Design Brief

6310 Hazeldean Rd. Development

December 2023

Review of UDRP's comments received on October 6th, 2022

CONCEPT SITE PLAN - PROPOSED IN FALL 2022

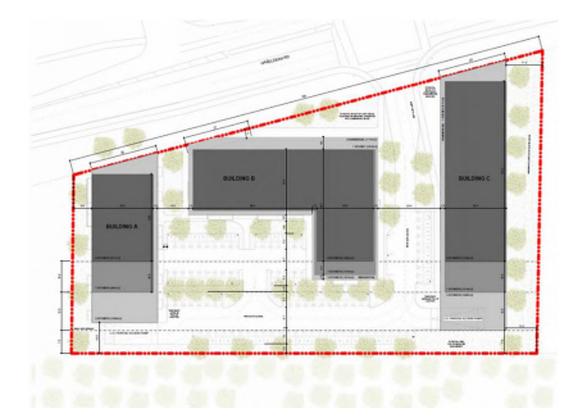
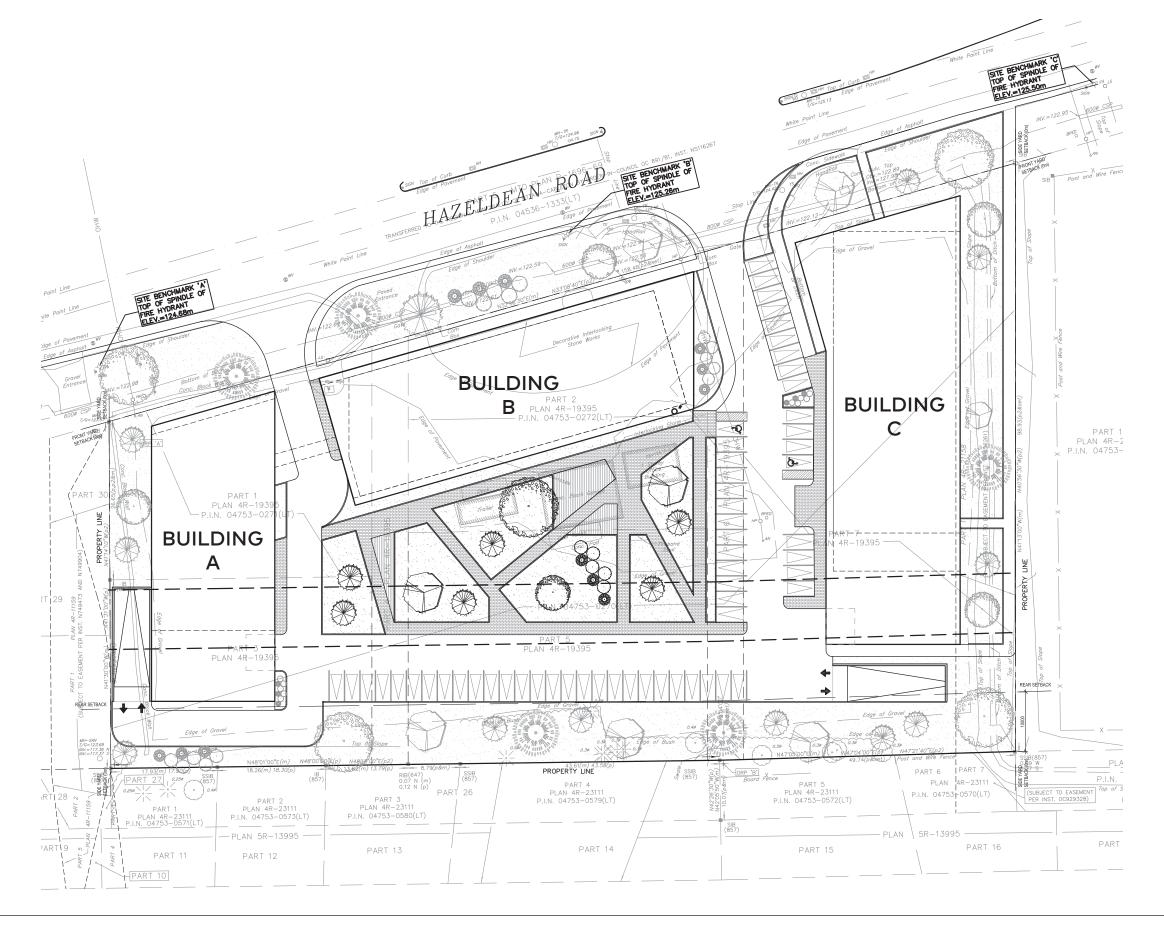
The Panel believes that the site will set a precedent in the area where a strong architectural expression and public realm vision is needed to embed the site into the greater landscape and neighbourhood context.

The Panel supports, in principle, more density on the site; however, there are more opportunities to enhance the public realm and landscaping and to build a sense of community while considering how the proposal will set a standard for the future.

At this stage of the development process, the Panel expects to see a proposal where the architecture has been resolved, is viable, will be built and become part of the neighbourhood. A more detailed proposal would enable the Panel to provide more wholesome comments and input.

The Panel expressed disappointment with the current level of resolution of the architecture.

The Panel recommends the City not grant the changes to the setbacks as the site provides enough space to accommodate the buildings while maintaining the setbacks requirements.

The Panel recommends increasing the density on Hazeldean Road and reorienting Building B to parallel the street to create an urbanized corridor. Should the building be parallel to the street, the Panel recommends connecting Buildings A and B with glazed volume. Additionally, the proponent should consider elongating the building to eliminate the north-south wing since the inside corner units of an L-shaped building have with limited access to light.

The proponent should consider relocating the drop-off area underground on the north side of Building C to provide access to all three buildings. This would open up the layby space and allow for more greenery and reconfiguration of the parking layout.

The Panel questioned the appropriateness and amount of commercial space on the ground floor, given retail may not be viable. The space could be used for residential amenities.

The Panel believes the site's configuration is dominated by parking. The proponent should develop a strong pedestrian realm proposal that accommodates bicycle parking and has a high-quality landscape with outdoor amenities and a residential character.

The Panel has concerns with the scale and massing on the site as the buildings do not reflect the neighbourhood's character and only relate to each other. The Panel recommends the proponent study the area and its architecture to establish a language that complements the neighbourhood.

The Panel notes the ground floors configurations are repeated throughout the site, and the suite plans might do not reflect the siting or architecture of the individual buildings. The proponent should consider providing a high-quality amenity at grade, as the amount of space allocated for each suite is questionable.

The proponent should consider more variety on the facades and larger glazed openings and the introduction of large family units to break up the sameness of the buildings. The proponent should also consider adding more glazing with masonry at key corners to provide amination at the ground floor level.

The Panel believes Building C should have more articulation to break up the long façade.

The proponent should consider stepping and terracing the building toward the neighbourhood to provide a more significant transition and greenery at the rear

The Panel has concerns with the parking at the rear, given the possibility of headlights spilling into neighbours' yards. The parking does not allow for an outdoor amenity area due to the limited open space. The proponent should consider eliminating parking at the rear or designing the open spaces first, before laying out the parking.

There is an opportunity to add a bosque of trees and have a wrap-around landscape adjacent to the townhouses to create a strong landscape design and to strengthen the existing buffer.

The proponent should focus on site sustainability by implementing stormwater management and providing opportunities within the landscape to integrate utilities.

Acknowledged, a new updated concept has been prepared that includes a strong contemporary architectural expression. This new proposal includes a stronger ground plane experience with ground floor accessible units and strong active entrances for the two buildings proposed.

Agree, the new concept provides a stronger presence to Hazeldean while providing a strong transition to the neighbouring properties to the south. Though a future ROW is considered in the site plan placement of the buildings, we anticipated that this new street scape will eventually include for stronger pedestrian sidewalks, a bike path and significant green space that is included in this proposal.

Acknowledged, the team has included Figurr Architects who have prepared a more detailed exploration of the development, including enhanced urban design experiences, building massings and aesthetics, as well as how the buildings reflect the existing urban conditions along Hazeldean Rd. and the neighbouring properties.

Acknowledged, responded to in previous comment

Acknowledged, the site planning in the new proposal respects all required setbacks.

Acknowledged, a new proposal by Figurr Architects new proposes a two building solution with a strong street face along Hazeldean. Massings and heights have been carefully developed to contribute to a strong main street façade, an appropriate transition to neighboring properties, as well as considering sun and shading of the massing against this and other neighboring sites.

Acknowledged, a new two building proposal has been prepared with a stronger centralized drop off for both buildings under building 1. Parking has now been concentrated within a two storey parkade structure (and u/g garage) that has been clad with light coloured panels and vegetated screens.

Acknowledged, commercial no longer part of new updated proposal.

Acknowledged, at grade parking has been greatly minimized to provide mostly for visitors. A new 2 storey parkade (and u/g garage) will house remaining parking. A large amenity terrace will be located above the garage parkade.

Acknowledged, this new proposal has a stronger contemporary language. This area of the city does NOT have a specific and strong existing building language. The area is dominated by a mix match of suburban single family homes, industrial lands and typical suburban commercial strip centres. We do not believe that these are great examples to draw from and believe that the new concept – through thoughtful massing, proper transitions, and enhanced green buffer areas - provides a strong refined aesthetic that actually responds to enhancing urban planes.

Acknowledged, the new proposal has been properly explored to include proper ground floor programming for these types of buildings. Programs have been located to enhance the public realm with clean open and active entrances and amenity areas along Hazeldean. Bike rooms, move-in rooms and access to other supportive programs have been properly located to further support the concept.

Acknowledged, the concept attempts to address these concerns with a strong contemporary design as also previously mentioned in past comments. Larger units will be part of the project but a final unit typology will be part of a future Site Plan Control submission.

Acknowledged, please see new proposed concept that has a two building solution with varying setbacks and material explorations.

Acknowledged, new concept has been primarily developed by exploring that major aspect along the neighbouring properties.

Acknowledged, a new enclosed parking structure integrated with the buildings has been proposed. This greatly reduces the at grade parking. Project will ensure a minimum fence line and significant 10m green buffer zone between the rear lot lines and any building or parking area.

Acknowledged, please see new concept that greatly increases the use of green landscaping and significant buffer zones.

Acknowledged, as the concept now evolves, this will be part of the proposed project.
